From: Neil Duffield
Sent: 30 April 2020 15:03
To: Helen Webster
Subject: RE: NYM/2020/0223/FL - Rounton House, RHB E11808- nymnp drawing 02C 30-04-20

PROJECT: Rear extension to Rounton House Robin Hoods Bay

Drawing: Existing and Proposed Elevations and Plans

DRAWING No: D11808-02 REV: C

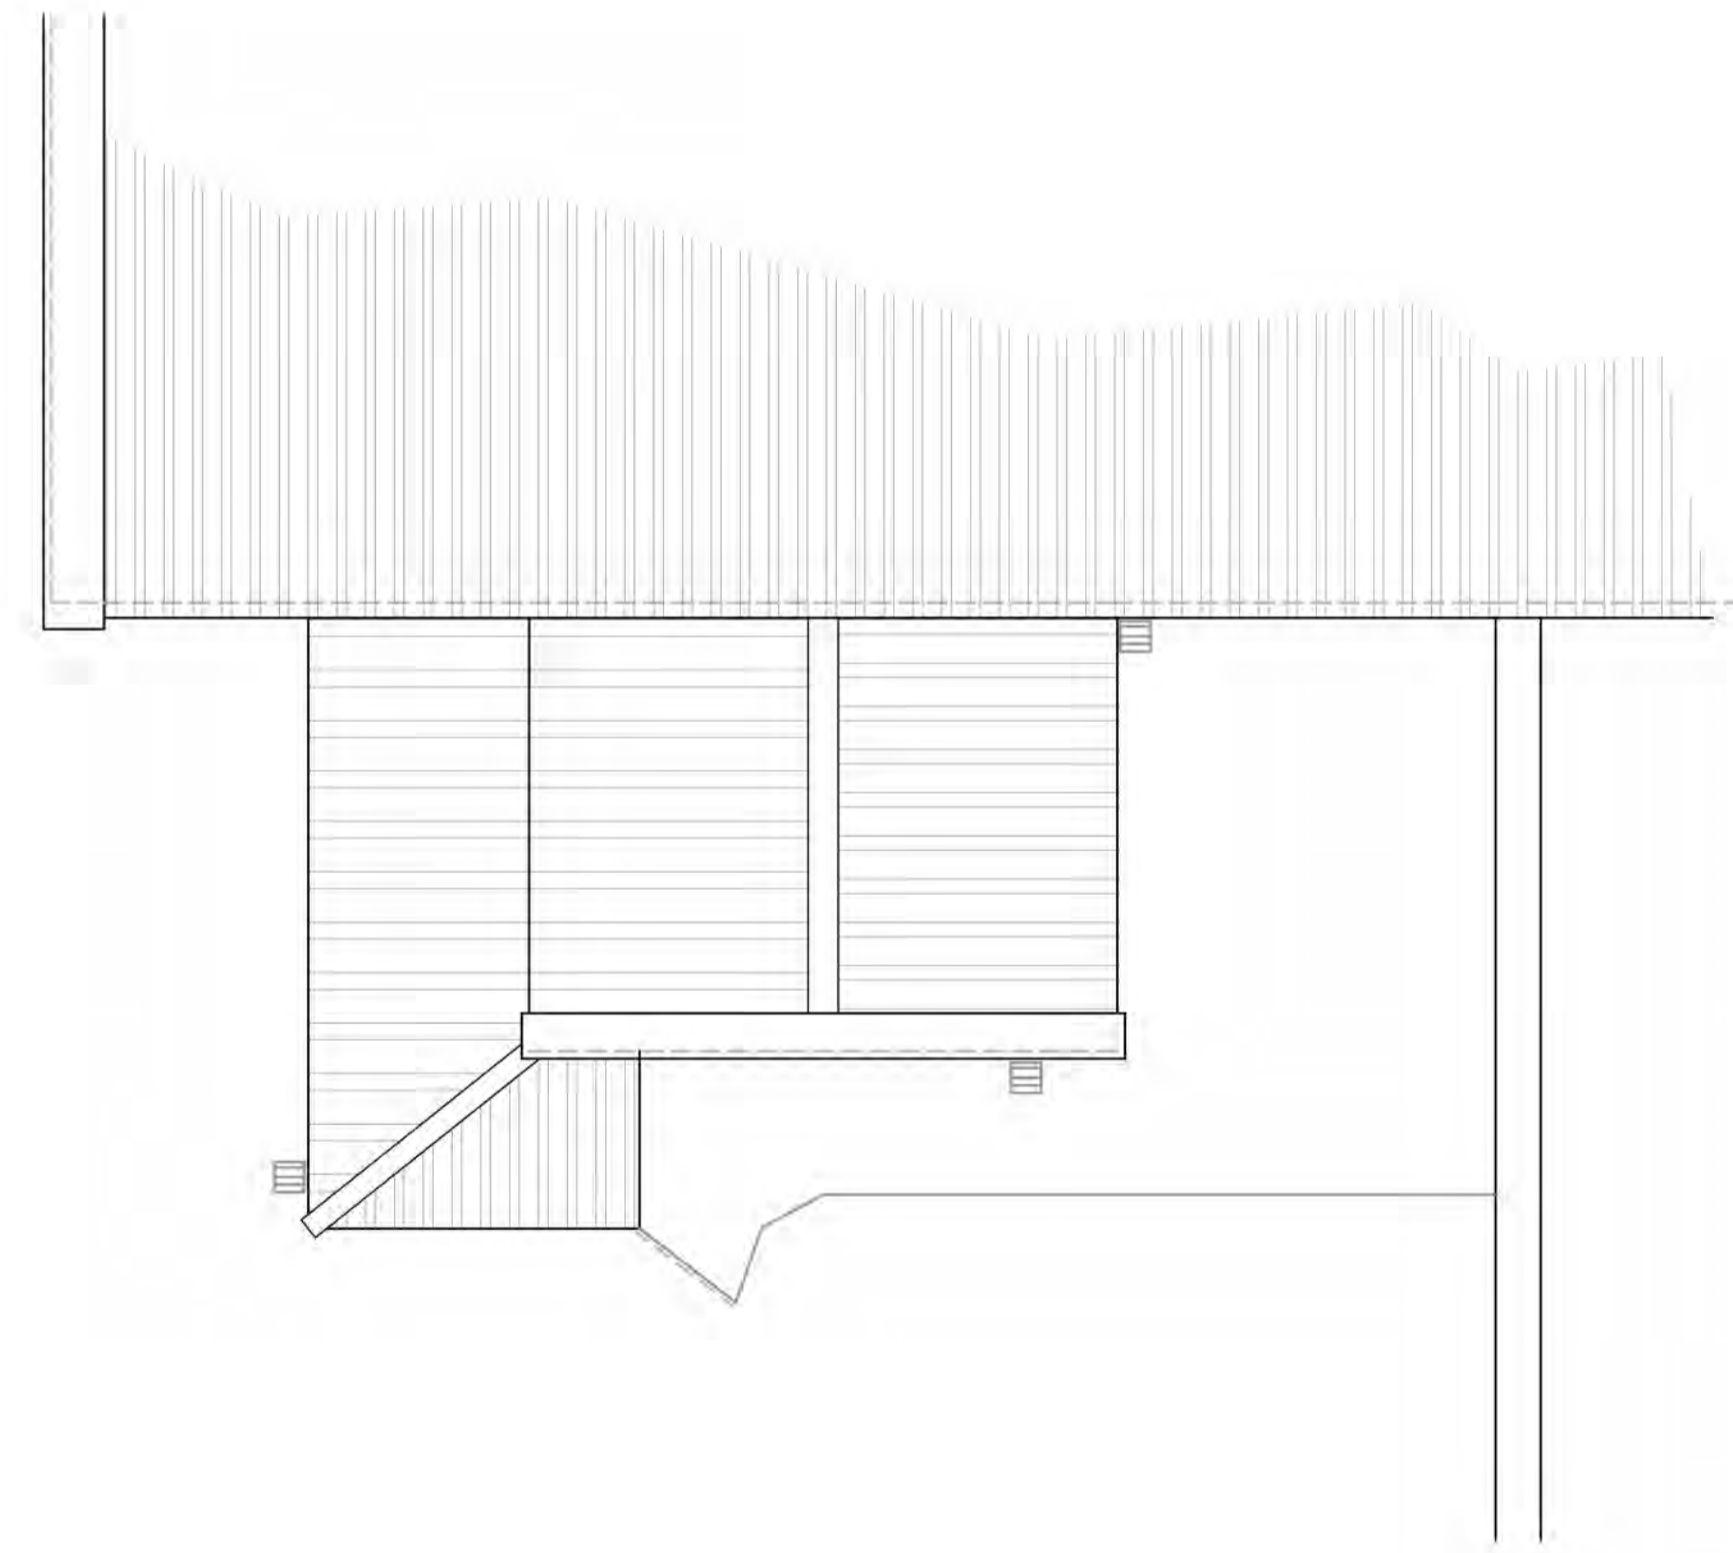
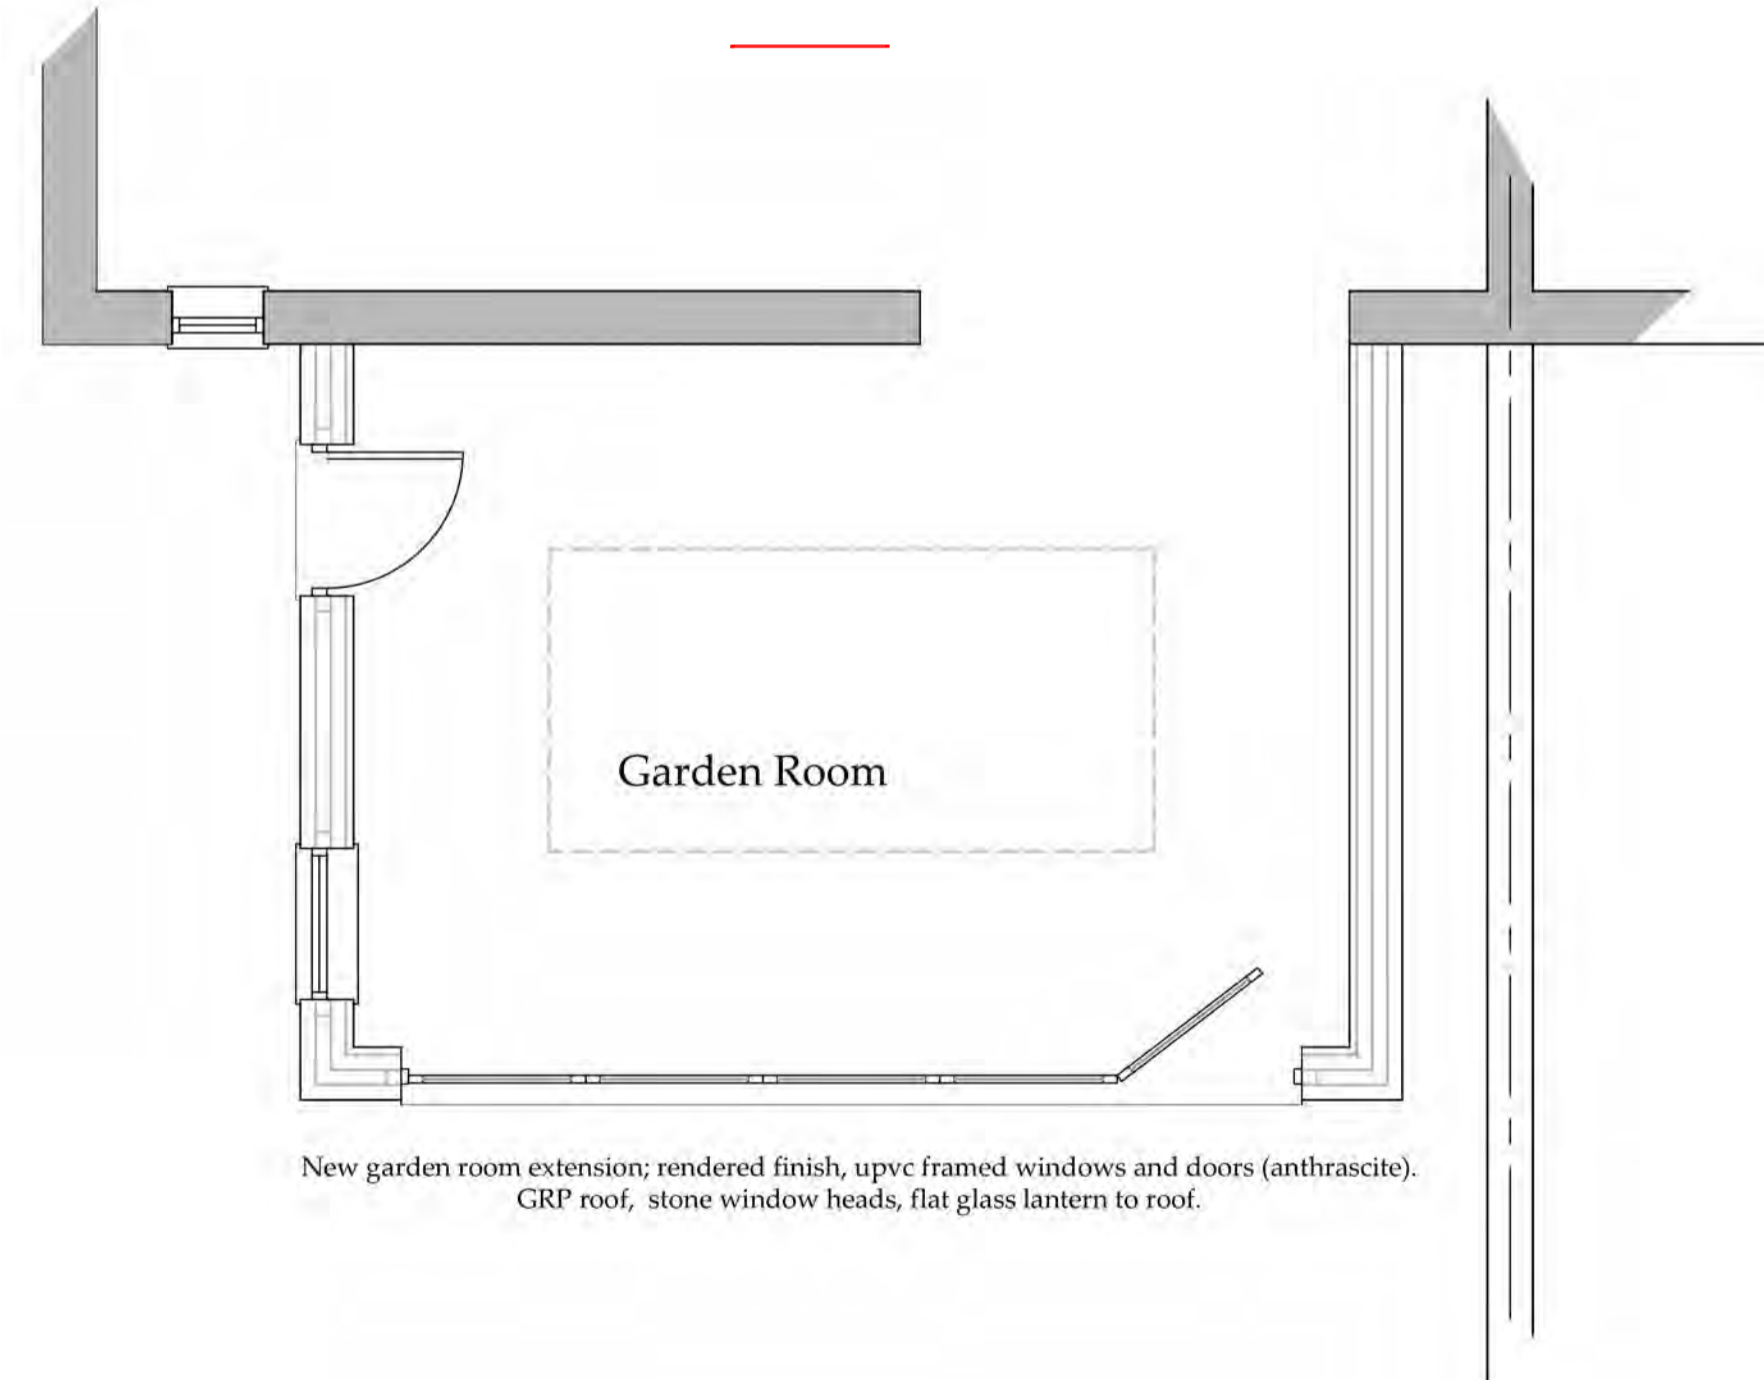
- 1. We will remove the parapet wall completely – this is fine, we will have to stick with the lantern roof as we don't have the height to get the pitch for a regular pitched roof with skylights.*
- 2. We will come in half a metre rather than the 1 metre suggested – coming in 1 metre will remove 6m² of floor space, there won't be much point at all in doing the extension and improving the property to lose all this extra floor space.*
- 3. We will extend to 5m rather than 6m – it is suggested that we come in 1.5m from our planned extension, however for the same reasons above there will be little point in creating the extension if the floor space is to be minimised so much. Furthermore at this distance we are still a very long way off being in view of the neighbouring properties. We are lower than many so there is no danger of us overlooking their outdoor space at this level.*

There are also changes to the window type, ie UPVC instead of aluminium as we originally specified.

The internal lobby has also been removed to help with floor area.

C	30/04/20	NID	Finishes notes and Lobby
B	29/04/20	CE	Reduced to suit Planners
A	18/03/20	NID	Issued for approval
